ENGINEERING INFORMATION RECORD

Document Identifier: 51 - 9004805 - 001

Title: FCS RSG - AFAS Verification - RAI Responses

This document provides responses to NRC RAIs on the AFAS setpoint verification analysis (attachment 4 of the following reference).

**Figure 1 Nodalization Diagram of Affected Steam Generator
Showing Boiler Section Noding**

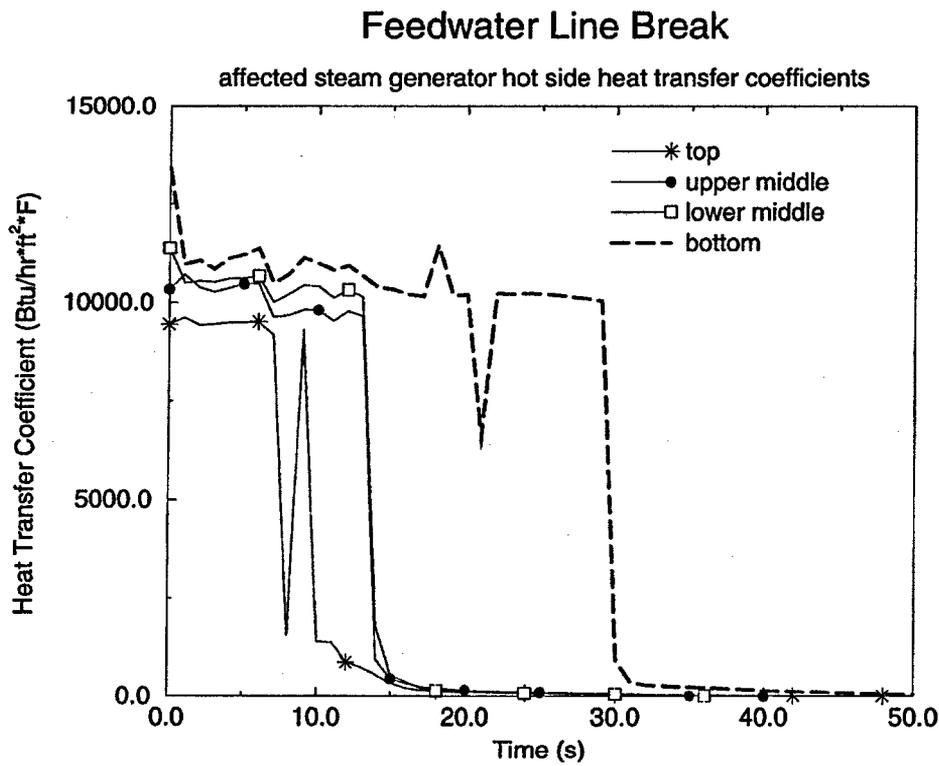
Discuss the SG heat transfer model in S-RELAP5 for events that experience SG dryout. Provide the values of SG dryout heat transfer coefficients used in the analysis of non-LOCA transients, in particular, the loss of main feedwater (LMFW) and feedwater line break (FLB) events.

The FLB scenario is presented first. The boiler section consists of four vertically stacked control volumes with two sets of heat structures representing the 'up' and 'down' portions of the steam generator tubes. Figure 1 shows a nodalization diagram for the affected steam generator. In that figure, component 524 represents the boiler section with node 524-1 representing the bottom node, 524-2 representing the lower middle node, 524-3 representing the upper middle node, and 524-4 representing the top node of the boiler section. The initial void fraction profile in the affected steam generator boiler section varies from 0.37 at the bottom to 0.81 at the top. In the first 10 seconds after the blowdown is initiated, the void fraction in the top boiler section transitions to above 0.97, and the heat transfer coefficient transitions from approximately 10,000 BTU/hr-ft²·°F to approximately 1,500 BTU/hr-ft²·°F. The void fraction transitions to all vapor by 40 seconds and the ultimate total heat transfer coefficient becomes approximately zero. The lower sections show similar characteristics at later times. Figure 2 shows the total heat transfer coefficients for the hot side, bottom through top, nodes from time 0.0 to 50 seconds. For comparison purposes, Figure 3 shows heat transfer coefficients from the unaffected steam generator. The quantities shown are from the structures representing the hot side. The nodal heat transfer coefficients remain relatively constant until their respective control volumes dry-out. Note that the heat transfer coefficient from the bottom node retains a finite value greater than zero throughout the transient. This is the effect of auxiliary feedwater on the nodal heat transfer coefficient.

Figure 5 Normalized Total Heat Transfer Versus Normalized Total Steam Generator Mass in Affected Steam Generator

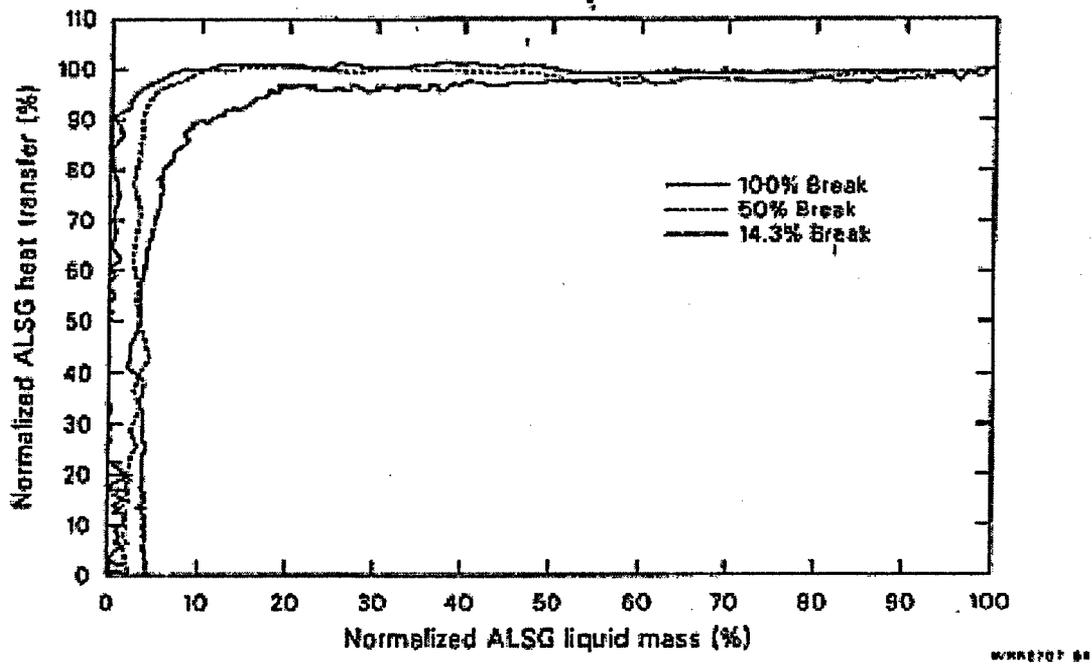
The Semiscale test data for FLB (as discussed in Section 4.3.3.2 of NUREG/CR-4945, dated July 1987) show that SG heat transfer capacity remains unchanged until the SG liquid inventory is nearly deleted. This is followed by a rapid reduction to zero percent heat transfer with little further reduction in the SG water inventory. In light of these test data, you are requested to verify that the heat transfer model used in the LMFW and FLB events (that experience SG dryout) is conservative as compared to the Semiscale test data.

The next figure, Figure 5, is presented to demonstrate that the S-RELAP5 calculations of feedwater line break are conservative with respect to Semiscale feedwater line break Tests S-FS-6, S-FS-11, and S-FS-7 (NUREG-4945). Figure 5 shows the normalized total primary to secondary heat transfer versus the normalized total steam generator mass for the affected steam generator from the previously mentioned tests and from selected S-RELAP5 calculations. Note that the data in this figure was digitized from the plot on page 70 of NUREG-4945, thus there is some uncertainty concerning the absolute values of the data, but the trends are approximated adequately. Figure 6 shows a reproduction of the NUREG-4945 figure for verification that the digitized data is acceptable.

In Figure 5, the data shows more than 90% heat transfer until the inventory is reduced to below 20%, after which the heat transfer is reduced ultimately to zero. The smallest break, 14.3%, decreases to zero from 20% to 5% inventory while the larger breaks show the heat transfer decreasing to zero over the span of 10% to 0% inventory. In contrast, the calculated heat transfer starts decreasing between 40% and 50% inventory. The early decrease is due to the top boiler node drying out for the break sizes shown. As the inventory further decreases, the next two boiler section nodes dry-out and the heat transfer again decreases. Finally, at approximately 10% inventory the bottom node becomes virtually empty and the heat transfer is approximately zero. The results shown are conservative with respect to the Semiscale data.

Although a 14.3% break calculation was not performed, it would be expected to show similar behavior as the other calculations. That is, dry-out in the top boiler node will immediately decrease the heat transfer. As the lower sections experience dry-out, abrupt drops in heat transfer will occur with decreasing inventory. The Semiscale data and the calculations show the same trend relative to break size. Thus, all break size calculations are expected to show less heat transfer than the Semiscale data. Therefore, S-RELAP5 calculates conservative heat transfer with respect to Semiscale.
